TRANSNUCLEAR
STANDARDIZED ADVANCED
NUHOMS[®]
HORIZONTAL MODULAR
STORAGE SYSTEM
FOR IRRADIATED NUCLEAR FUEL

SAFETY EVALUATION REPORT

Figure 4.1 Example of COBRA-SFS noding (showing channels, rods, and slab nodes) for all fuel assemblies and guide sleeve structures in model of NUHOMS 24PT1-DSC

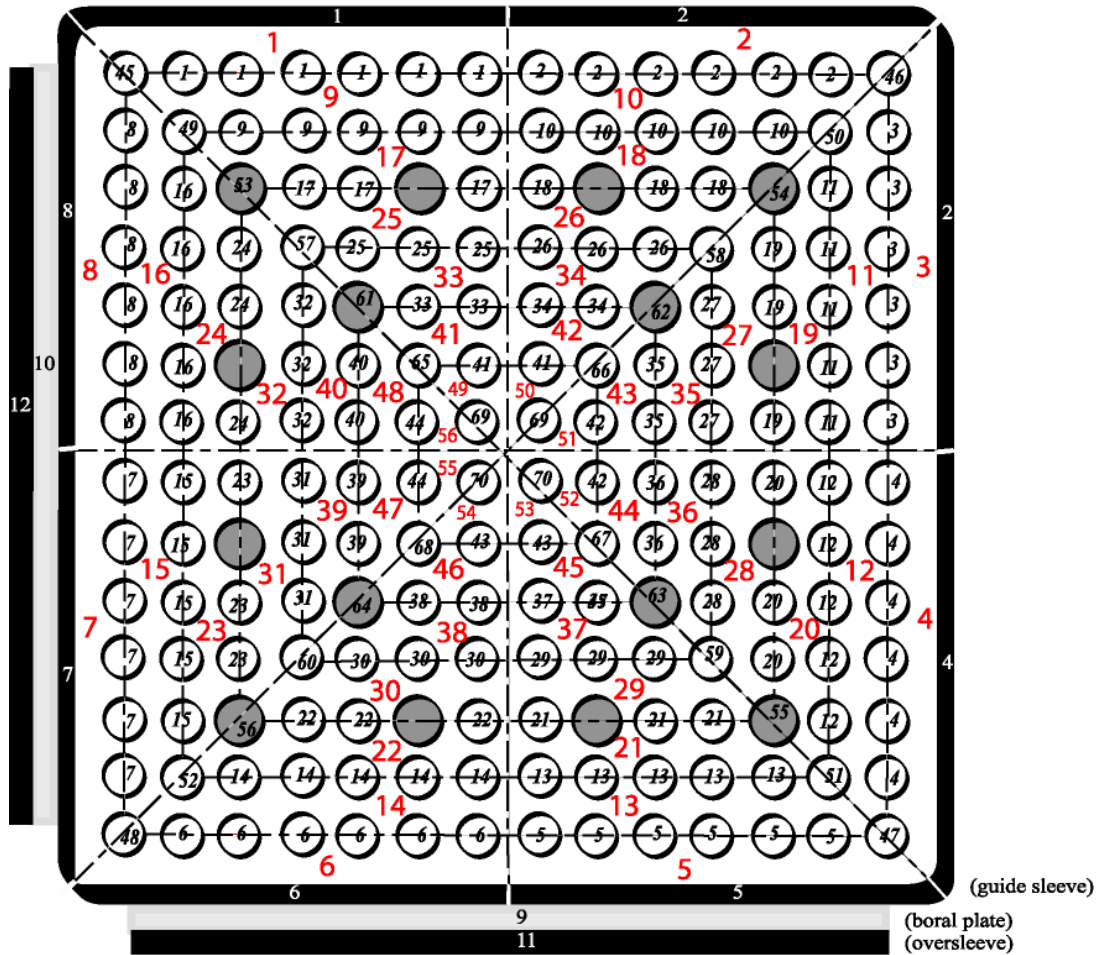
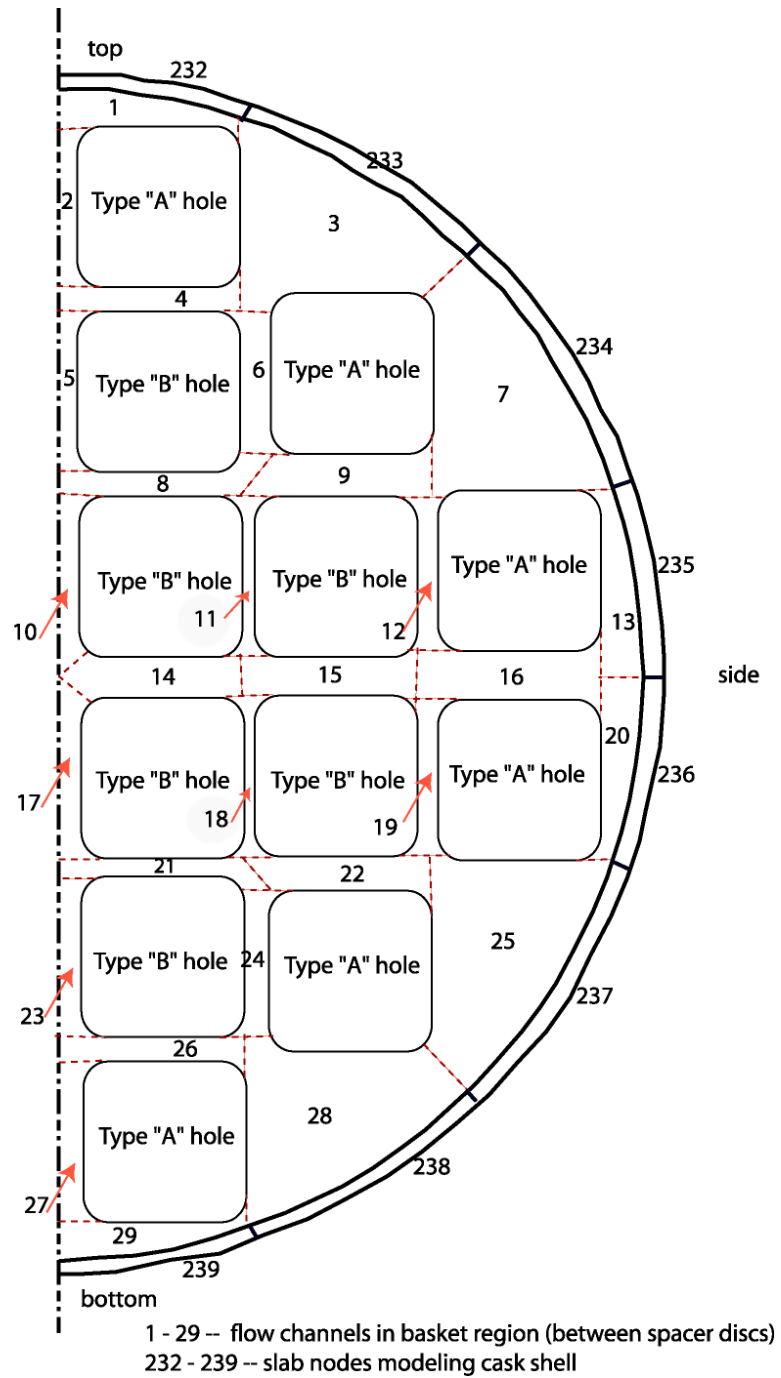
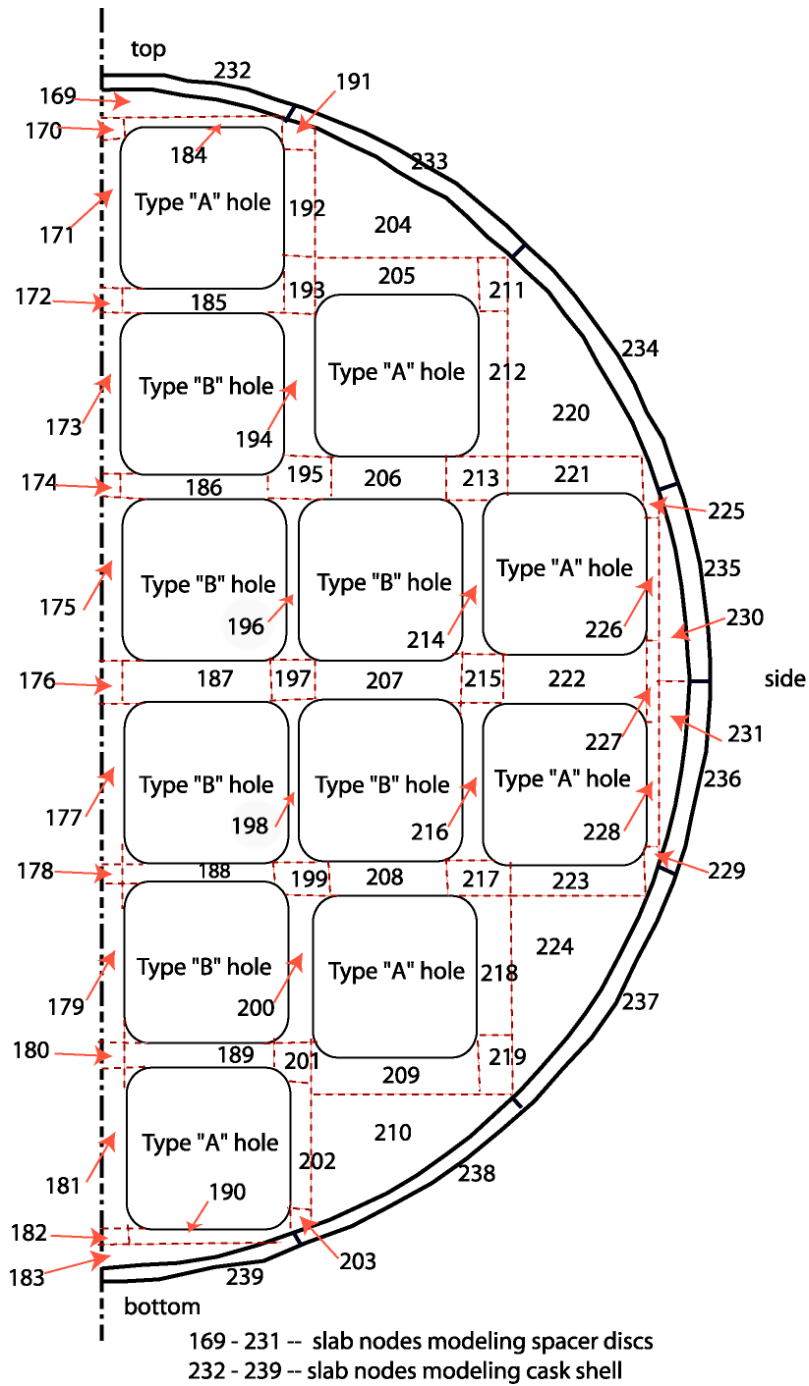
Upon comparison of the radial temperature plots of the hottest cross section of the 24PT1-DSC provided by the applicant in response to Request for Additional Information No. 2, and by PNNL, the staff noted a discrepancy in the temperature of the fuel assembly regions between the two models. While the analysis performed by PNNL indicates that the fuel cladding temperature is within the calculated fuel temperature limits, and is therefore, acceptable, the staff believes that the applicant's methodology for determining maximum fuel cladding temperatures, as presented in the SAR, is non-conservative for several reasons. First, the applicant's model uses a homogenized region for the fuel assembly with an effective thermal conductivity or "smeared" property approach in their thermal model. This method provides an average temperature for the fuel assembly and does not provide a precise peak cladding temperature for the hottest fuel rod within the assembly. The result reported by the applicant in the SAR is actually a maximum average temperature for the fuel assembly region. Second, the applicant provided a limited number of nodes per fuel assembly to record the fuel assembly temperature, which does not accurately capture the temperature gradient that exists across the fuel assembly, nor the temperature of individual fuel rods. This is in contrast to the PNNL model which accurately models individual fuel rod temperatures within the assembly and the PNNL model indicates the maximum temperature to be a specific rod within the hottest fuel assembly. Finally, the applicant's thermal code has not been validated against actual fuel temperature data, and therefore cannot be considered reliable for predicting fuel cladding temperatures given the current fuel parameters.
